ADDENDUM 1

OJRSA Project #2027-02

General Water Reclamation Facility Installation Projects

August 26, 2026

Figure 5-3 Alternative #2 Pump from AB#1 to AB#5

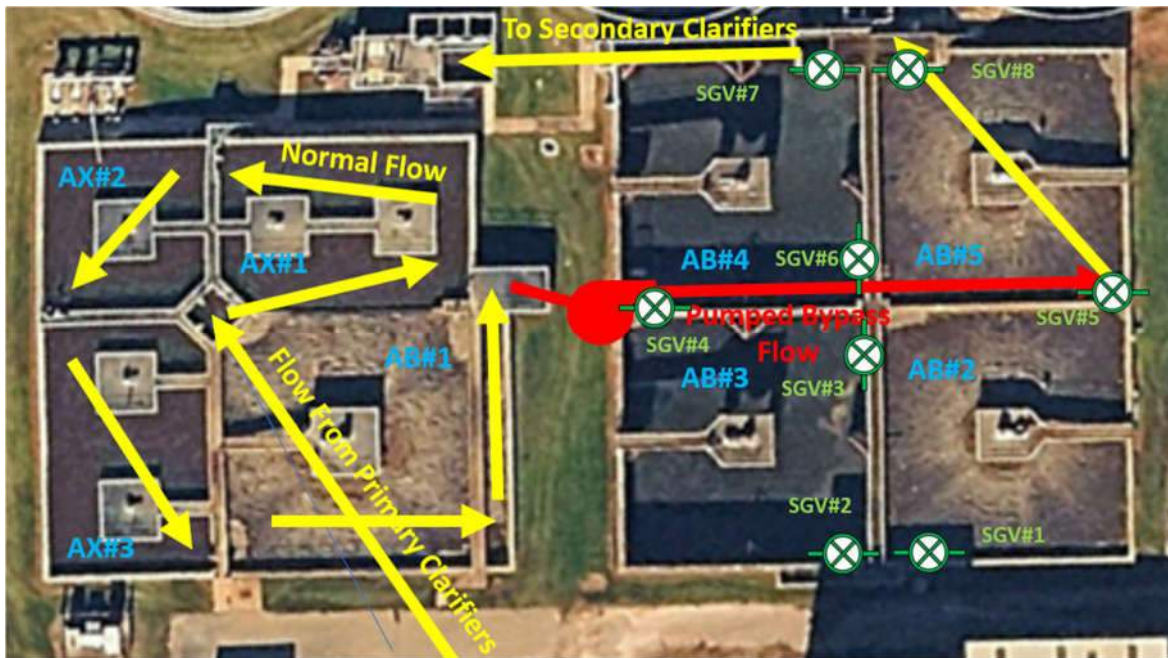
Clarification Item 3: The OJRSA wants to use Alternative #2 as identified in Section 5.4.2 in the attached *Sluice Gate Valve Replacement at OJRSA's Coneross WWTF* report as prepared by Goldie Associates in December 2025. See following pages for report.

In this scenario the influent sluice gate to AB#5 (SGV-5) would be closed and the wastewater pumped from AB#1 into AB#5 at SGV-5. Because AB#2 will be shut down and unaerated, its contents must be pumped into AB#5 as part of the bypass.

As in Alternative #1, the bypass pump will be controlled by using a level sensor in AB#1 and modulating the pump to maintain a level set point in AB#1.
